Post/Hazeltine Associates

This Historic Sites/Structures Letter evaluates a revision to the approved plans for a project for the Santa Barbara Museum of Art located at 1120 State Street (APN 039-232-021) and 1130 State Street (APN 039-232-020). Preliminary plans for the project were evaluated in a Revised Phase 1-2 HSSR that was reviewed and accepted by the Historic Landmarks Commission in May of 2014. Subsequent revisions to the plans were evaluated in a HSSR Letter Report prepared by Post/Hazeltine Associates dated March 3, 2015.

**Santa Barbara Museum of Art
 Phase 3**
 Building Renovation, Facility & Art Gallery Improvement Program
 1130 State Street
 Santa Barbara, CA 93101

Figure 1 Detail of Cornice and Rafter Tails, South Elevation, looking west

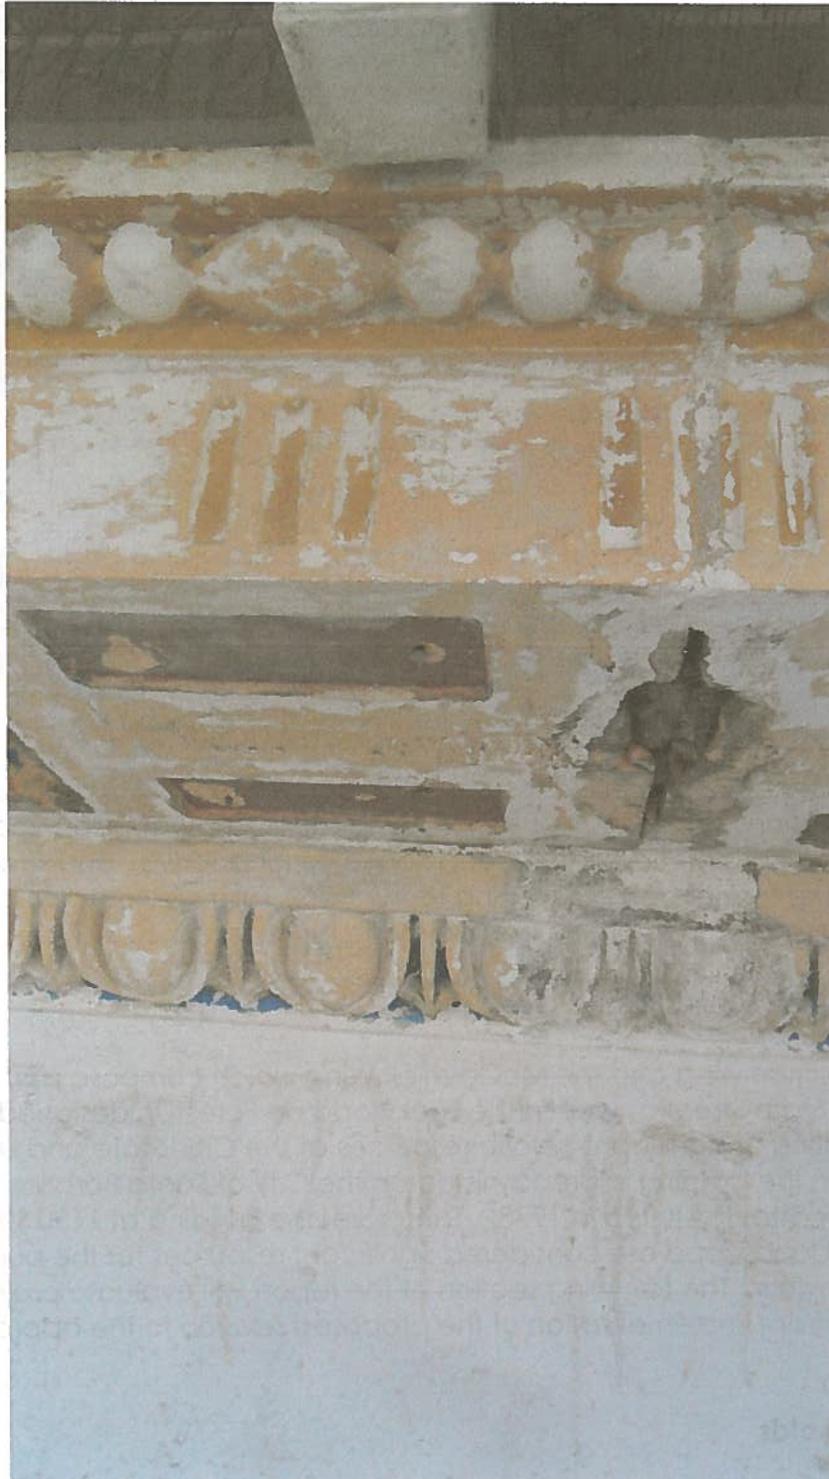
The applicant proposes revisions to the plans reviewed and approved by HLC in 2015. The approved project included the removal of a 45-foot section of cornice and rafter tails located on the south elevation of the original post office wing (Figures 1 – 3, Appendix A, Sheet 2AD1.20). The removed section of cornice and rafter tails was approved for re-use in an interpretive display located either onsite, offsite at the Ridley

Tree Education Center or offered to the Santa Barbara Historical Museum for their permanent collection. The section of cornice and rafter tails was approved for removal to accommodate construction of a second floor exterior doorway and second floor addition linking the former post office wing to the Peck wing. Project plans for the relocation and re-use of the cornice can be found in Appendix A.

3A1.08

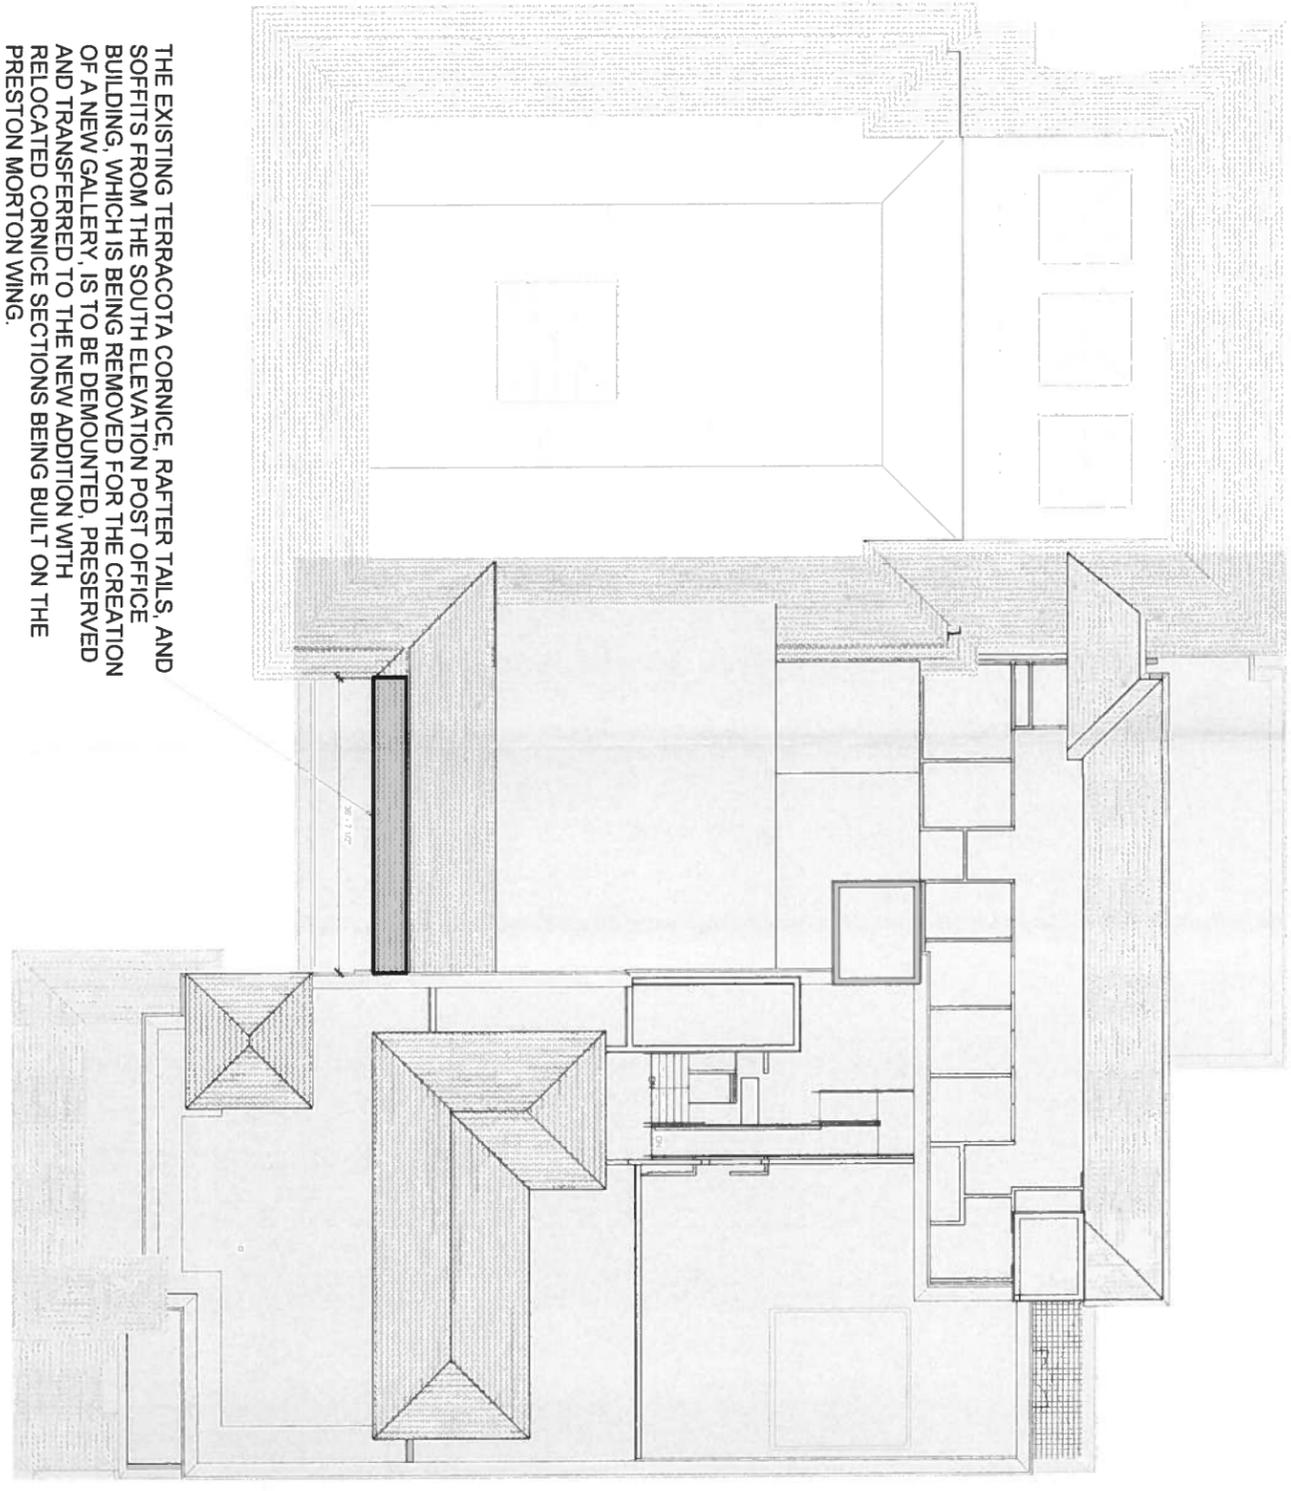
- Relocate the section of cornice and rafter tails that were approved for removal by the HLC from the south elevation of the post office wing to the west elevation of the new second floor gallery facing State Street (see Appendix A, Sheets 2AD1.20, 3A1.08 & A3A2.02). This would allow the cornice to continue to function as an architectural feature, which was its original function;

THE EXISTING TERRACOTA CORNICE, RAFTER TAILS, AND SOFFITS FROM THE SOUTH ELEVATION POST OFFICE BUILDING, WHICH IS BEING REMOVED FOR THE CREATION OF A NEW GALLERY, IS TO BE DEMOUNTED, PRESERVED AND TRANSFERRED TO THE NEW ADDITION WITH RELOCATED CORNICE SECTIONS BEING BUILT ON THE PRESTON MORTON WING.

3A2.02

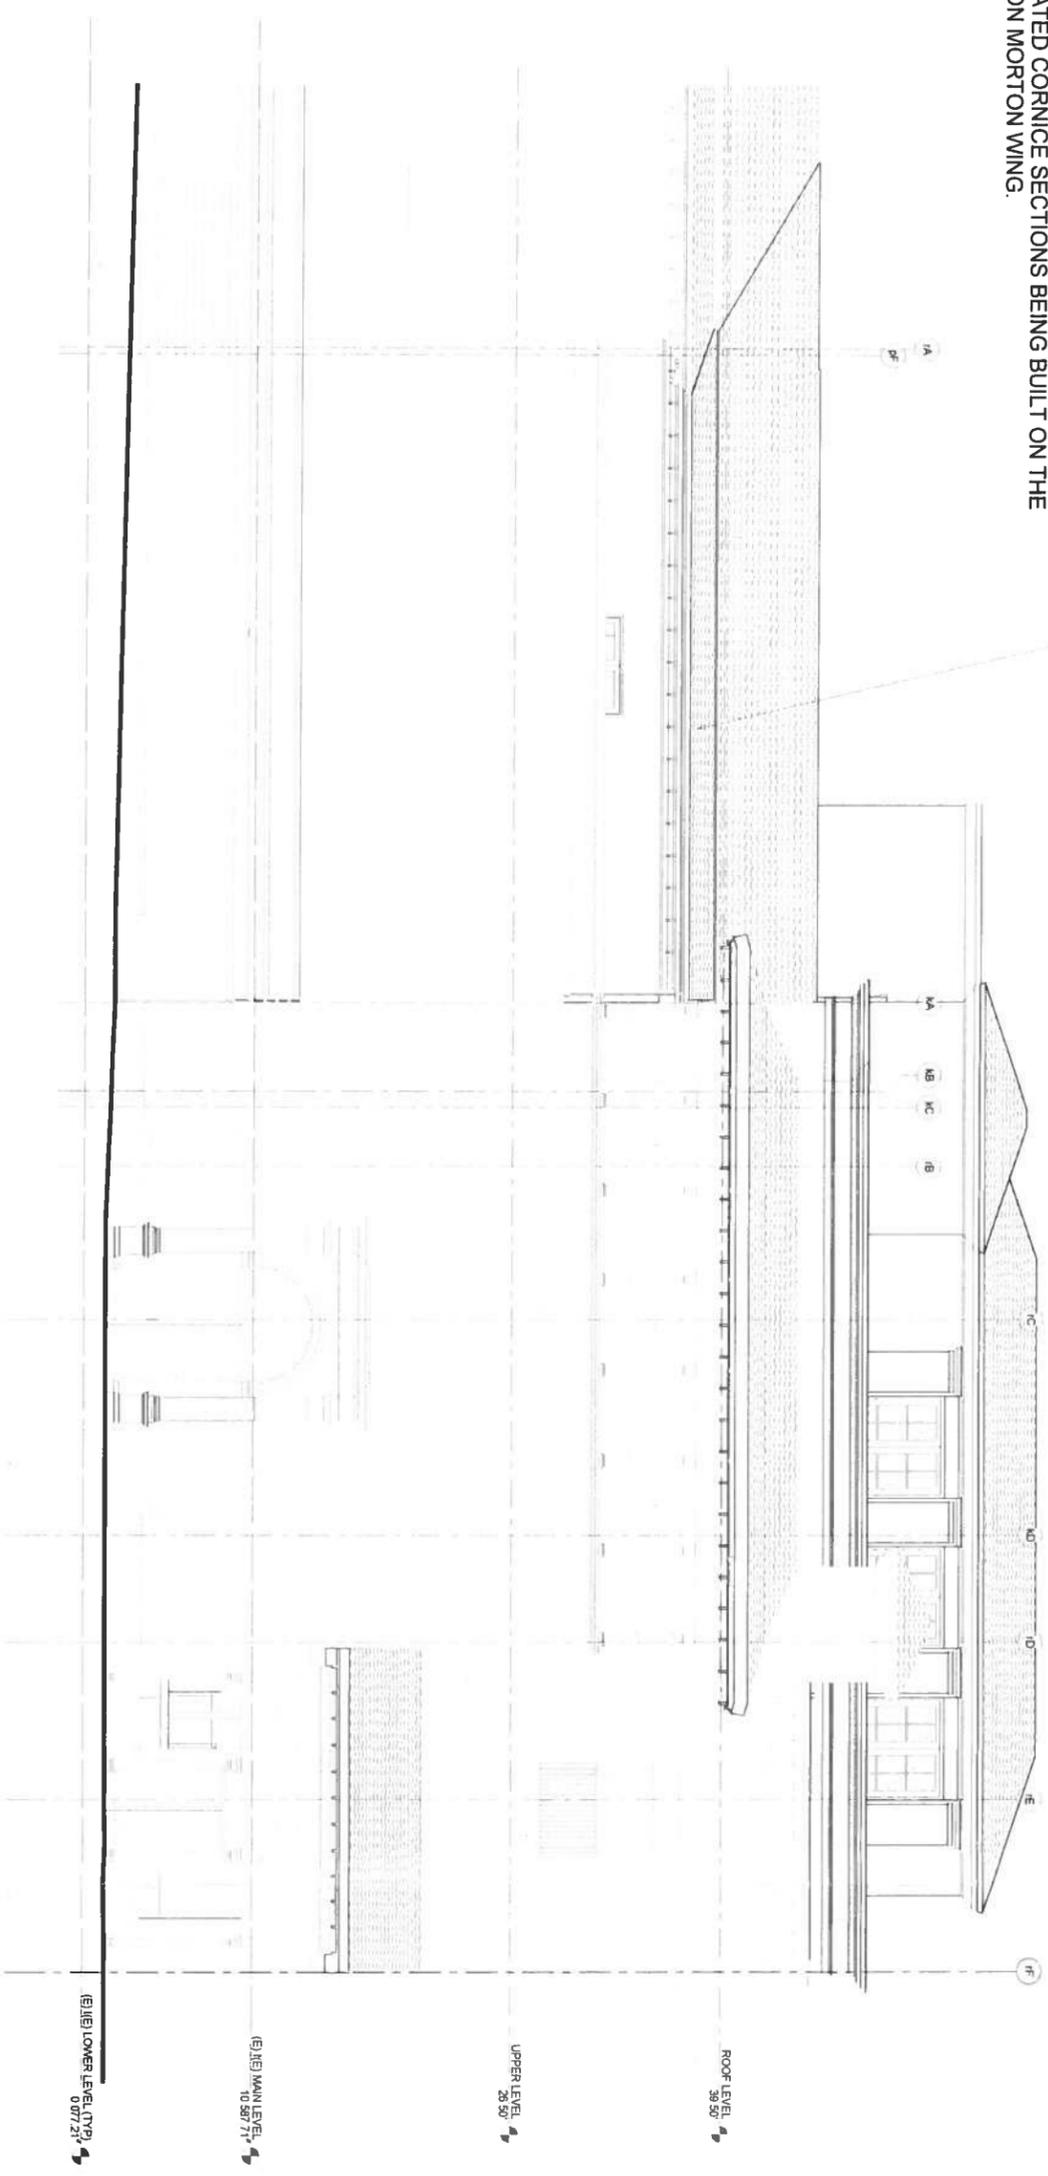
The revision to the approved project proposes to relocate an approximately 36-foot, 7.5-inch section of the 45-foot section of cornice approved for removal from the south elevation of the post office wing to the west elevation of a new second floor gallery facing State Street (see Appendix A). The remaining approximately eight-foot section of the dismantled cornice will be offered to the Santa Barbara Historical Museum. Copies of the letter and the response of the Santa Barbara Historical Museum will be submitted to the City of Santa Barbara Urban Historian to document that this requirement has been fulfilled. The revised proposal to relocate the cornice and rafter tails on site would accomplish the following:

THE EXISTING TERRACOTA CORNICE, RAFTER TAILS, AND SOFFITS FROM THE SOUTH ELEVATION POST OFFICE BUILDING, WHICH IS BEING REMOVED FOR THE CREATION OF A NEW GALLERY, IS TO BE DEMOUNTED, PRESERVED AND TRANSFERRED TO THE NEW ADDITION WITH RELOCATED CORNICE SECTIONS BEING BUILT ON THE PRESTON MORTON WING.
